RE: ENGINEER CERTIFICATION FOR SUNDANCE PRES. PL. (C17-D1U)
CERTIFICATION STATEMENT DATED 10/7/98

RE: SUNDANCE (C17-D1U) GRADING & DRAINAGE PLAN AND S.O. 19

**SUNDANCE
CLIFFORD INDUSTRIAL PARK
TRACT B-1-A-2**

GRADING & DRAINAGE PLAN

BERNALILLO COUNTY		NEW MEXICO	
TRACT B-1-A-2, SEC 14, T11N, R3E CLIFFORD INDUSTRIAL PARK			
SUNDANCE GRADING & DRAINAGE PLAN			
McDowell Engineering Inc.			
Designed JSM	Drawn STAFF	Checked JSM	Sheet of
File SUN0197T	Date DECEMBER, 1997	1	1

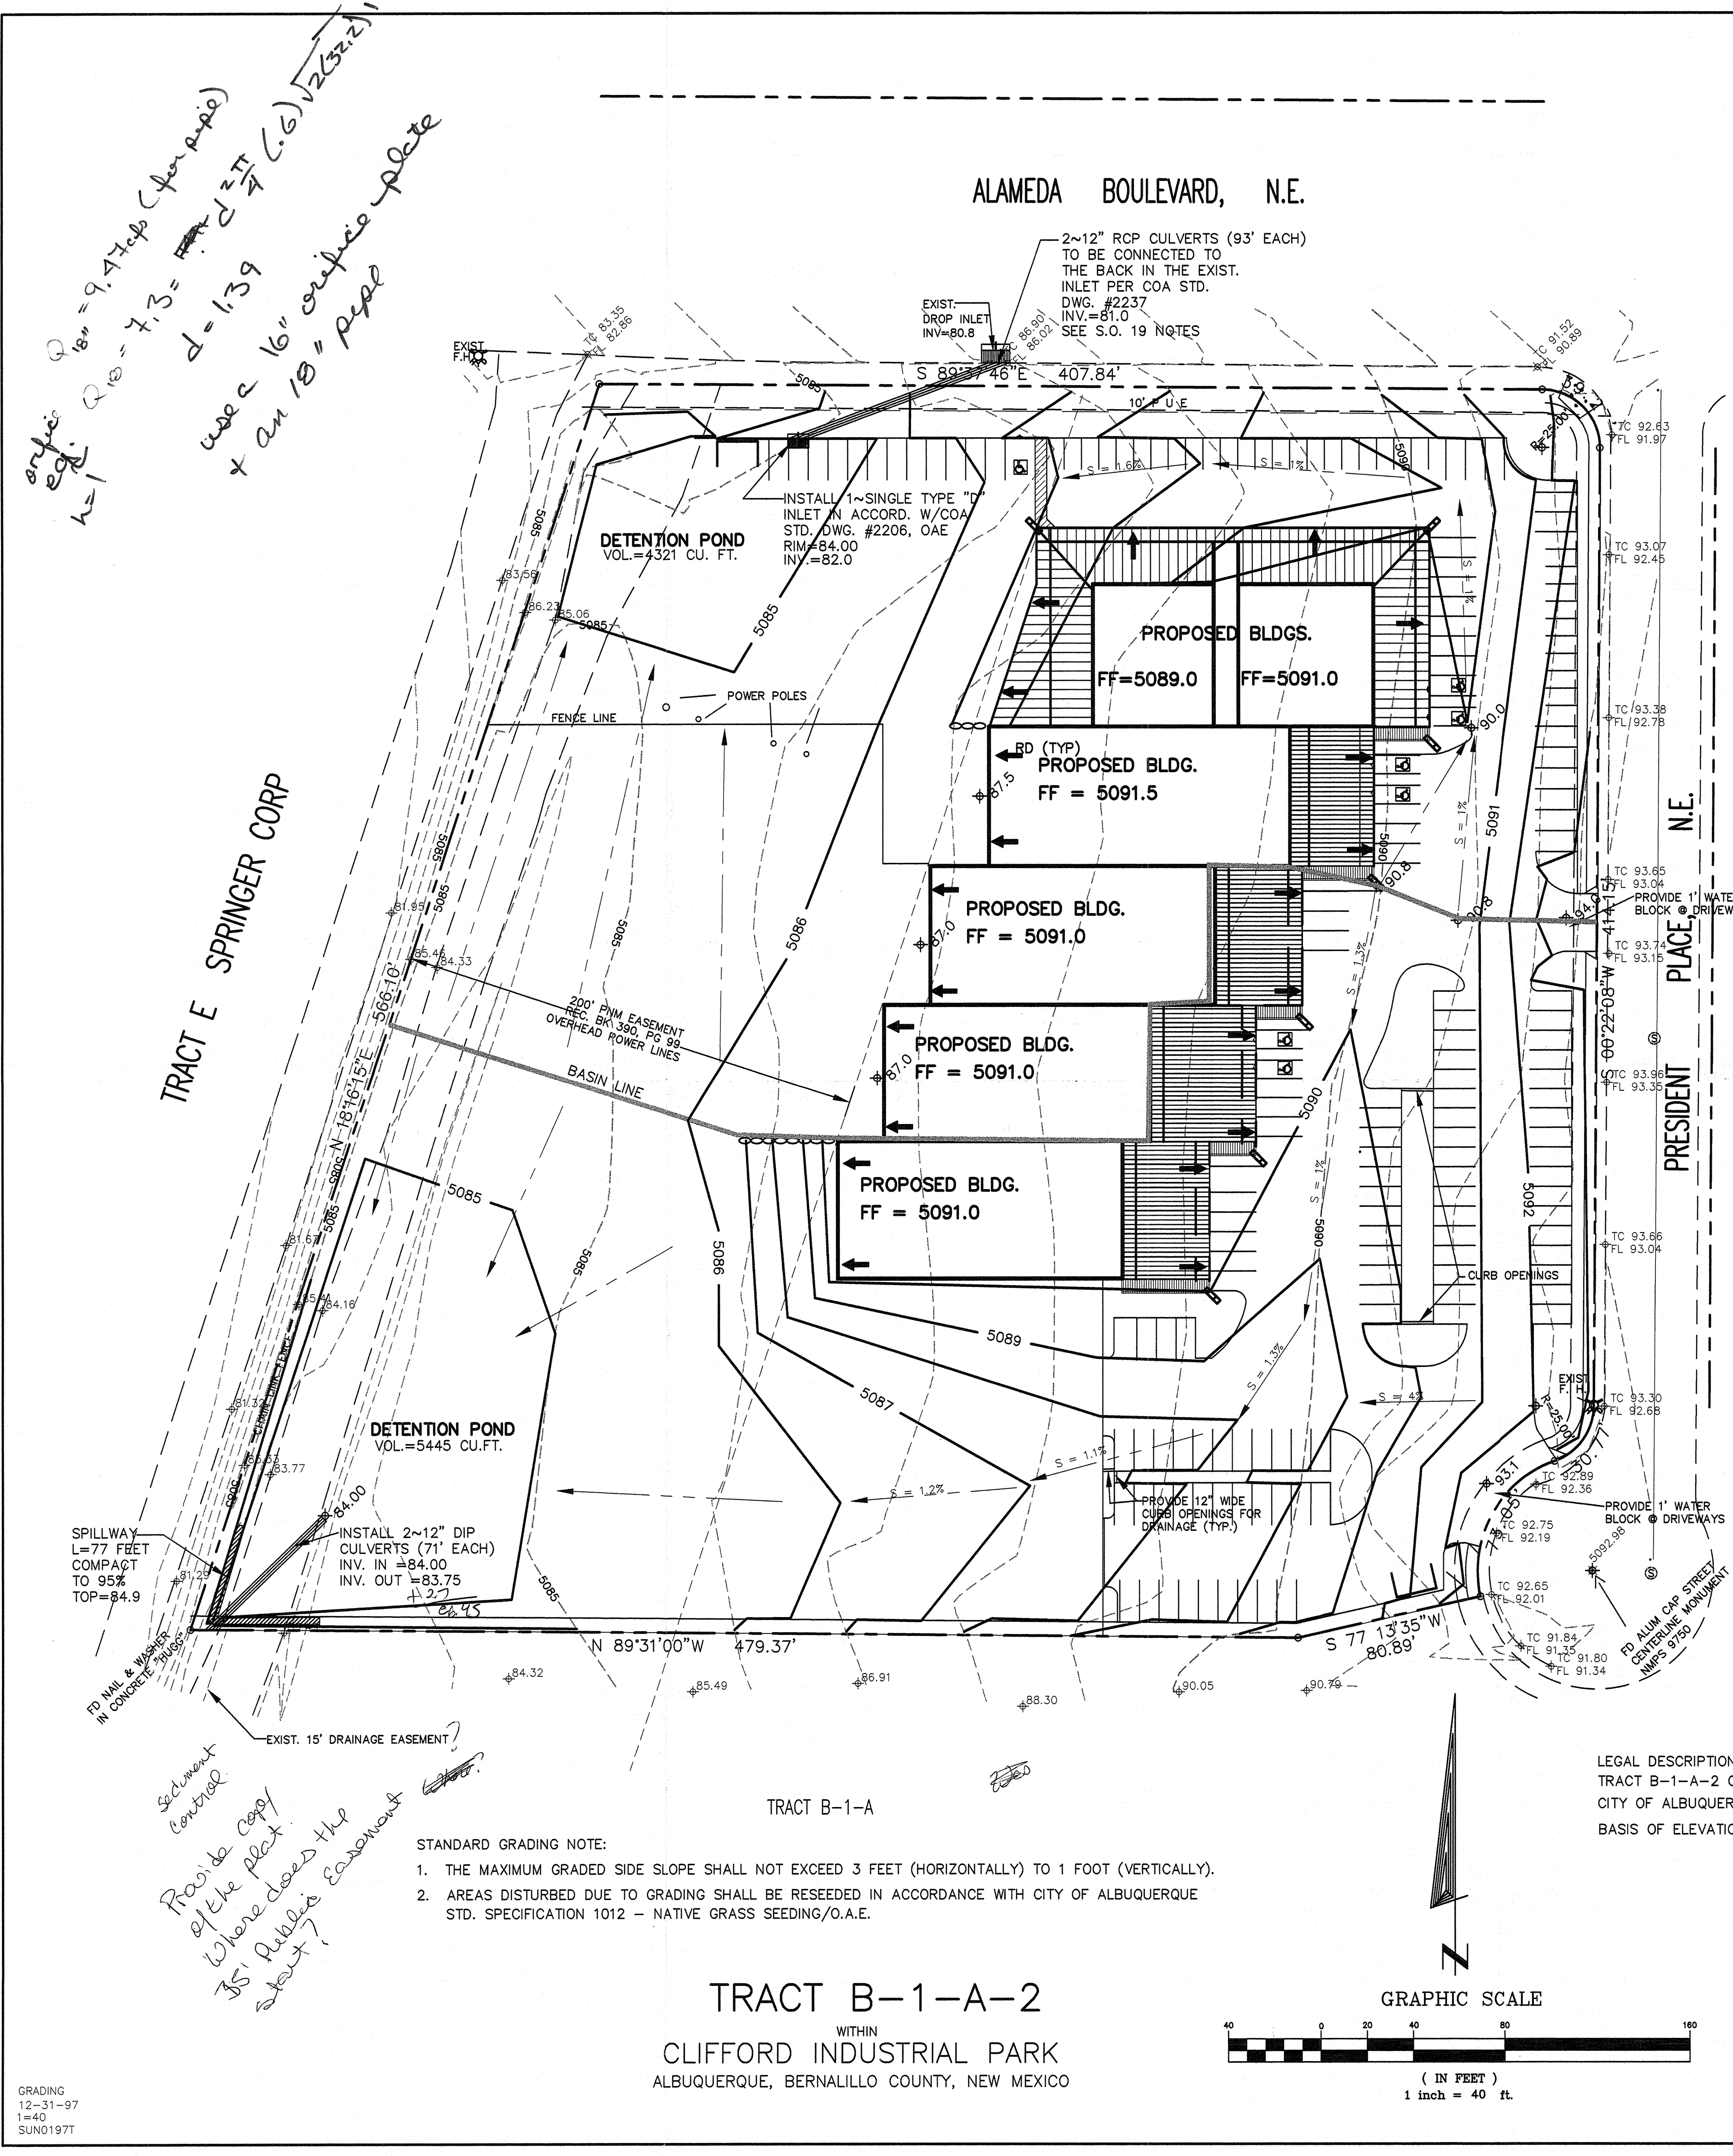
We received your comments dated January 30, 1998 and offer the following response in the same numerical order listed.

1. Rip rap protection has been added to the pond design and should eliminate sediment from entering the existing concrete channel.
2. We are using 2~12" culverts to tie into the existing inlet in Alameda because of capacity requirements and minimum size requirements shown on the standard detail. The existing inlet is a double "C". We have modified the alignment of the pipes tying into the inlet which comply with the standard detail.
3. A legal size portion of the plat is attached.
